METROPOLITAN GOVERNMENT OF NASHVILLE AND DAVIDSON COUNTY

STAFF RECOMMENDATION 3809 Whitland Avenue January 21, 2015

Application: New construction-addition; Partial demolition
District: Whitland Neighborhood Conservation Zoning Overlay
Council District: 24
Map and Parcel Number: 10413002300
Applicant: Brian Haun, Allard Ward Architects
Project Lead: Paul Hoffman, paul.hoffman@nashville.gov

Description of Project: This application is for a rear addition to this contributing building, and partial demolition at the rear of the building.

Figure 1. Front elevation of the house, after the proposed addition. The arrow points to the section that projects beyond the side wall of the house’s second story.

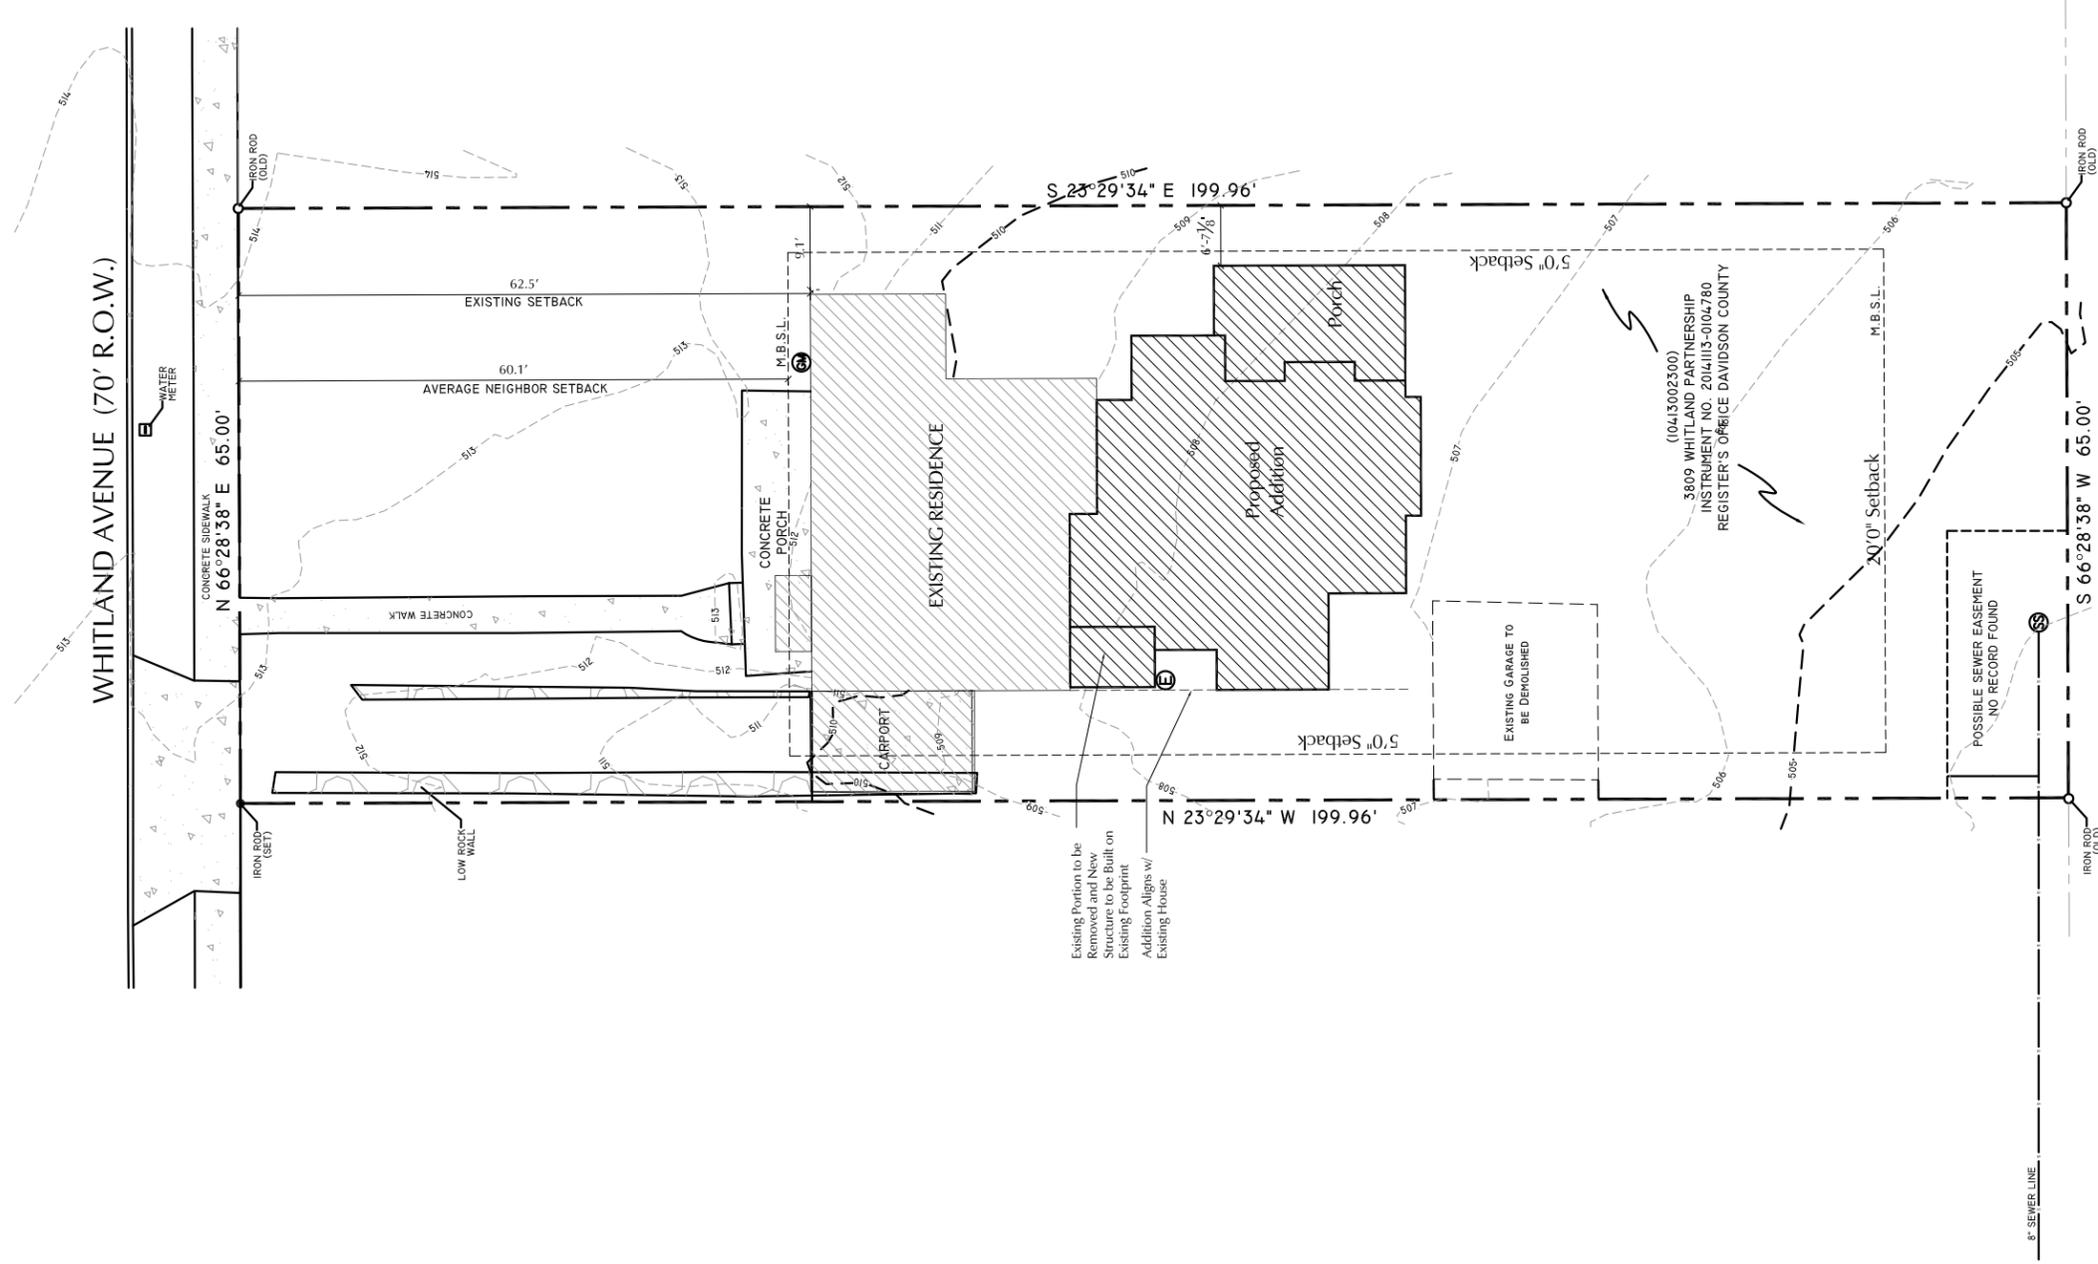
The addition will be wider than the existing house. A one-story porch extends beyond an existing one-story side wing by two feet (2’). A two-story portion of the addition will extend past the two-story side wall by approximately five feet (5’) (see Figure 1). Staff finds the one-story porch to be appropriate as it is primarily obscured by the existing house and the design guidelines allow for additional width when the lot is wider than sixty feet, which this one is, but recommends that the two-story portion not extend beyond the side-walls of the house because its two-story massing will be highly visible and will have a negative impact on the historic home.

With the conditions that the eave height be lowered to match the house and that the two-story portion not extend beyond the side-wall of the house, the project meets section II.B.1.a and b.

Drawings:
Demolition Plans

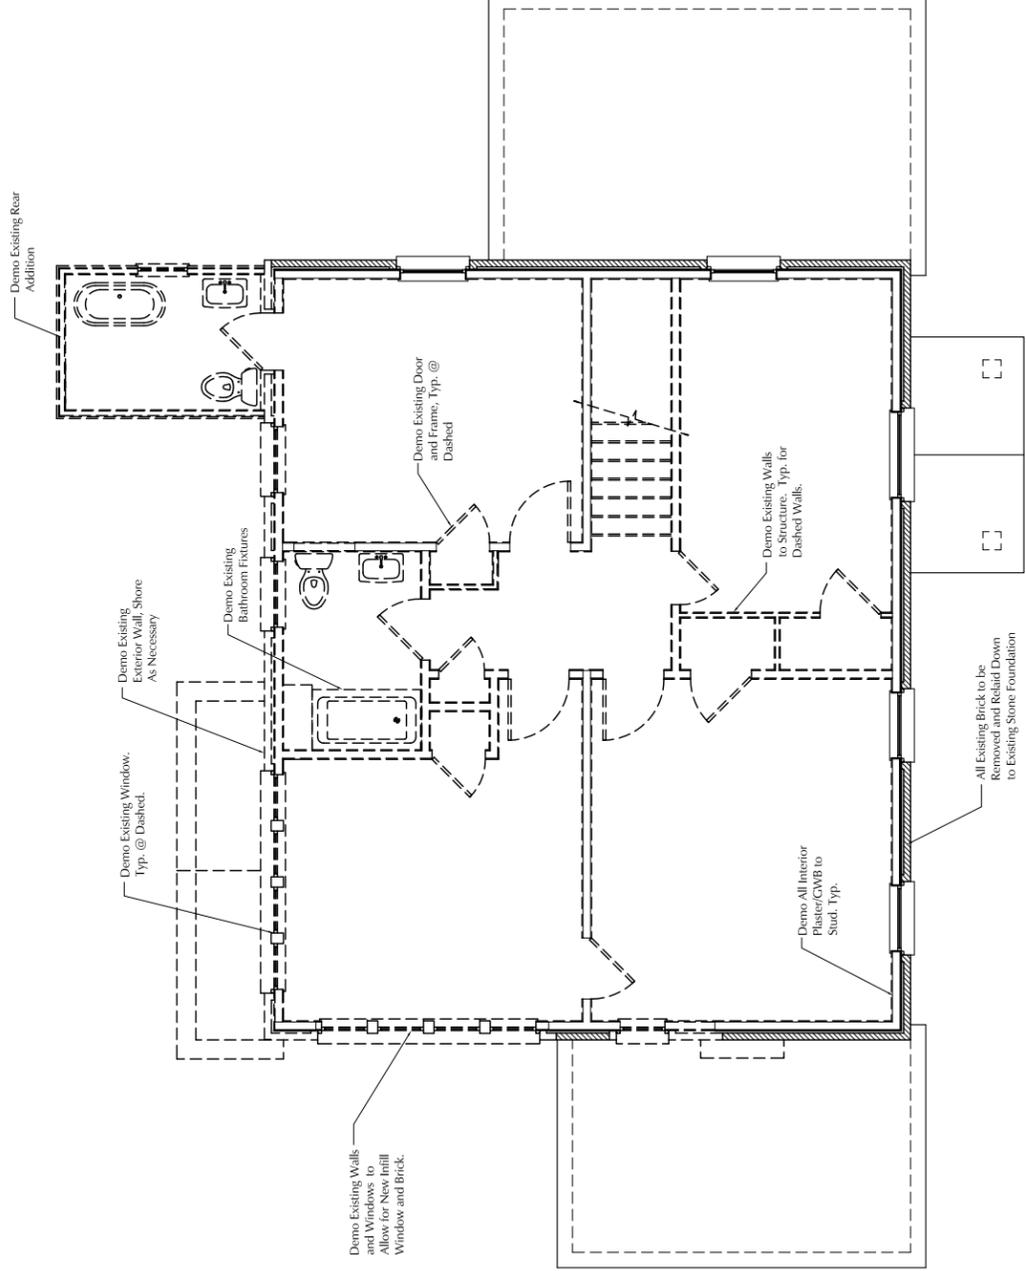
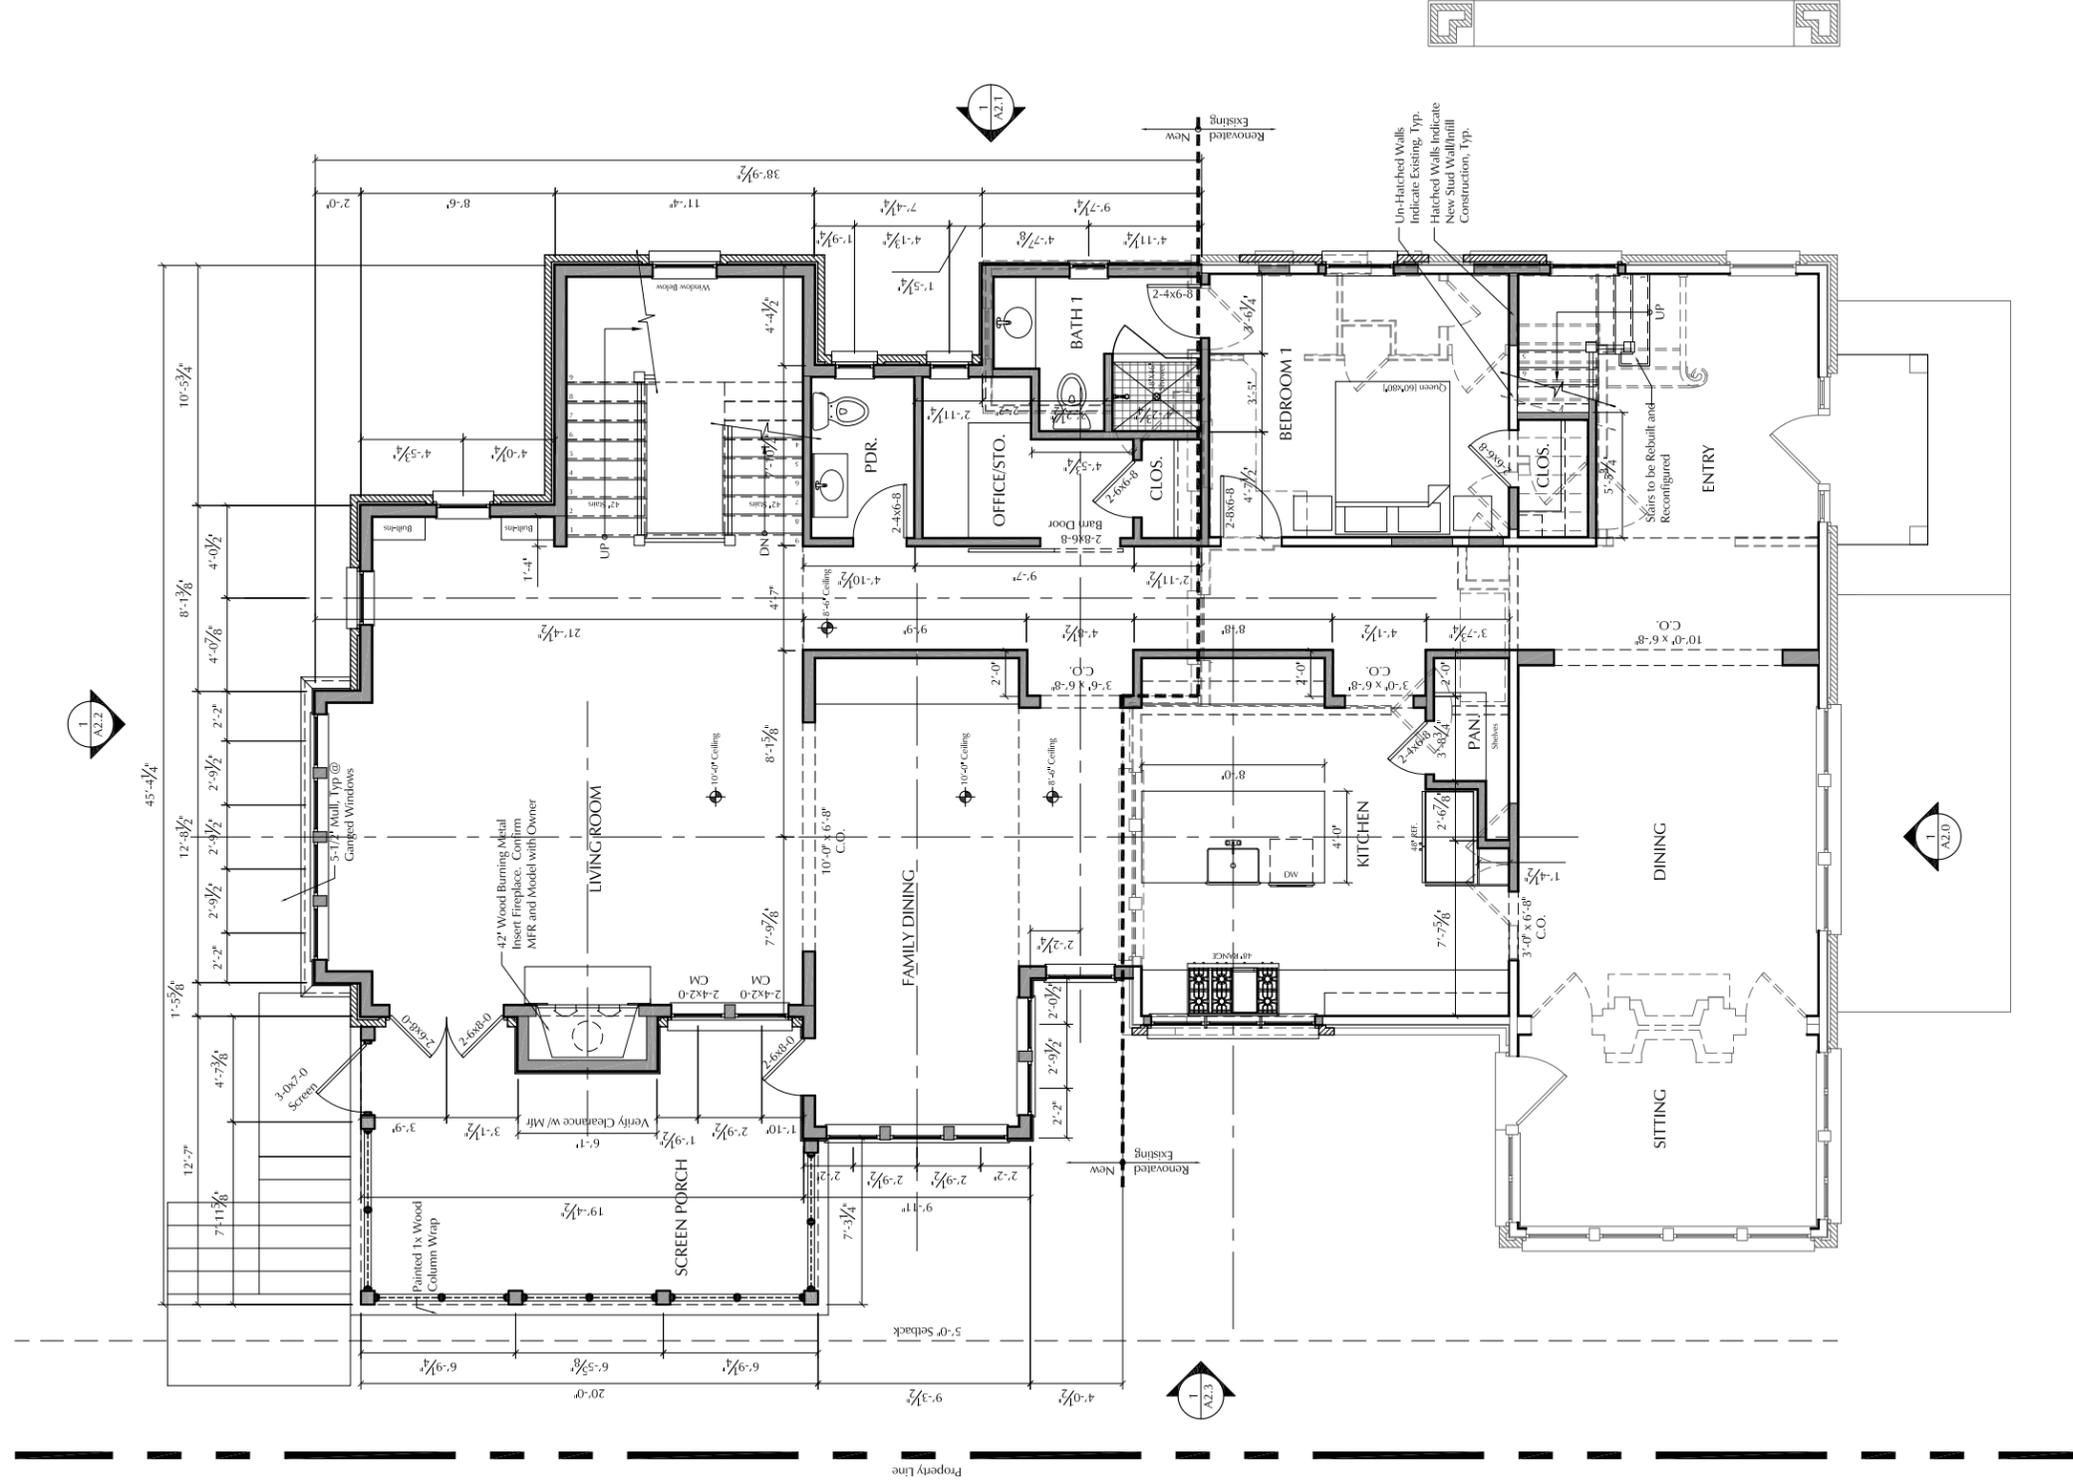
Demolition: Demolition is proposed for most of the rear wall of the house, as well as the left rear corner. In addition, the bricks will all be removed, due to their poor condition, and reapplied. Staff recommends review of the demolition and bricks to assure that such drastic measures are necessary.

1. Staff inspect the condition of the existing masonry to verify the need to remove and relay the brick;
2. Staff inspect the right rear corner to verify the need to fully demolish the rear corner on the second level;
3. Lap siding have no more than five inches (5”) reveal;
4. The eave height of the addition be no taller than the existing eave height of the house;
5. The two-story portion on the east side be revised not to project wider than the side wall of the second story of the existing house;
6. HVAC and other utilities be located at the rear of the house, or on a side façade beyond the midpoint of the house;
7. Staff approve the final details, dimensions and materials of windows and doors prior to purchase and installation; and,
8. Staff approve new masonry for color, dimensions and texture.

1 West Elevation

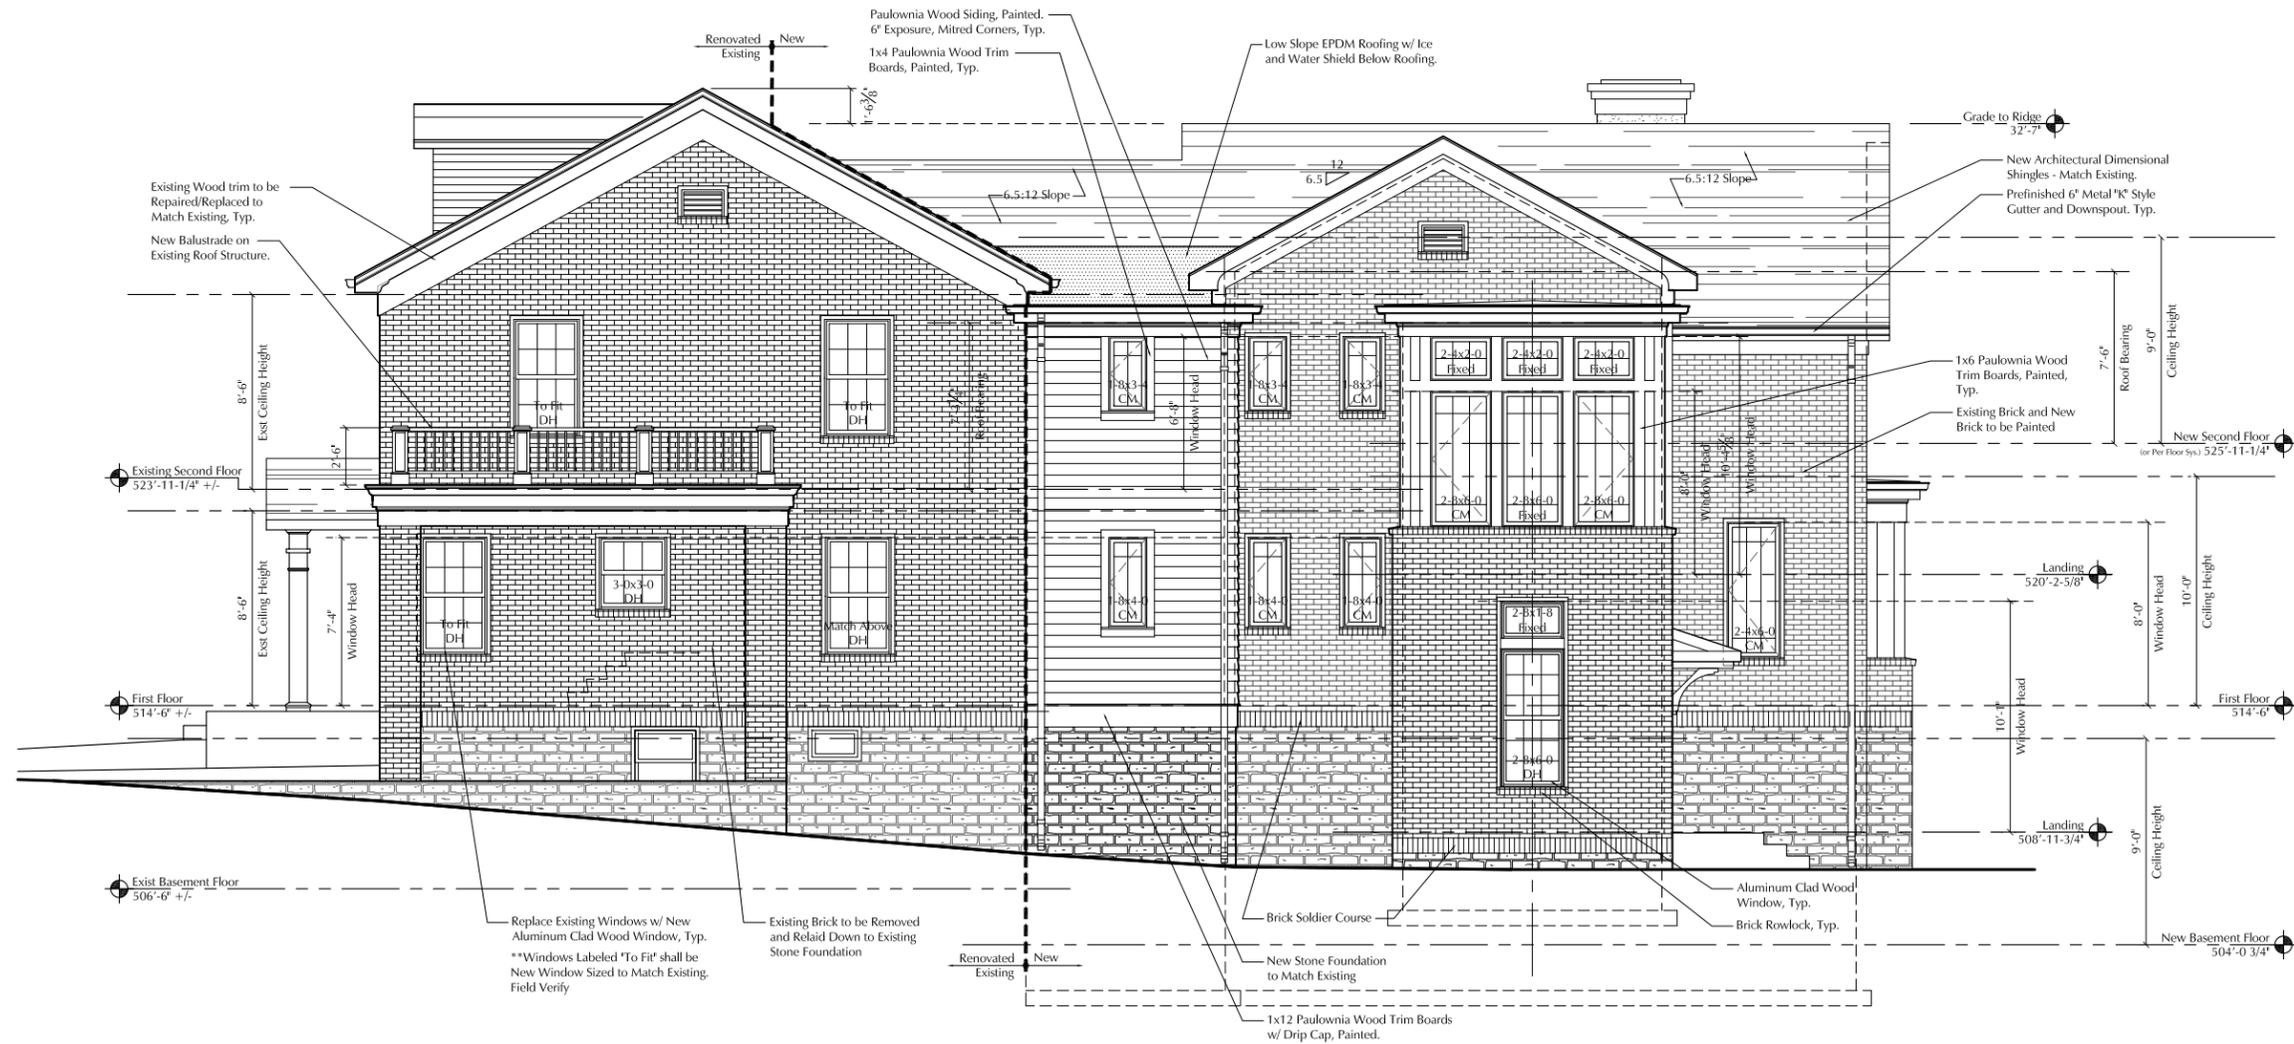
Height & Scale: The addition will have a maximum ridge height that is one foot, six inches (1’6”) lower than the ridge of the house. The addition’s foundation height will match that of the house. The eave height on the east elevation is higher than the house for an expanse of twenty feet (20’). Staff requests the addition’s eave height be reduced to the existing eave height of the house or less.

Materials: The addition will primarily be clad in brick. The connection to the house will be wood siding. The elevations show the reveal at six inches (6"). Staff requests the siding have no more than five inches (5") of reveal. Trim will be wood. The foundation will be a stone veneer to match the existing foundation. The roof will be architectural shingles in a color matching the existing roof. The windows and doors will be aluminum-clad wood windows. Staff asks to approve the final window and door selections prior to purchase and installation. The screened porch will have wood columns and structure, and aluminum screen panels. The chimney will be finished with stucco. The existing balustrade is indicated to be replaced, but the materials were not indicated. Staff requests approval of the new balustrade. With conditions of staff's final approval of the windows and doors, and balustrade, and that the siding have a maximum five inch (5") reveal, staff finds that the project meets section II.B.1.d.
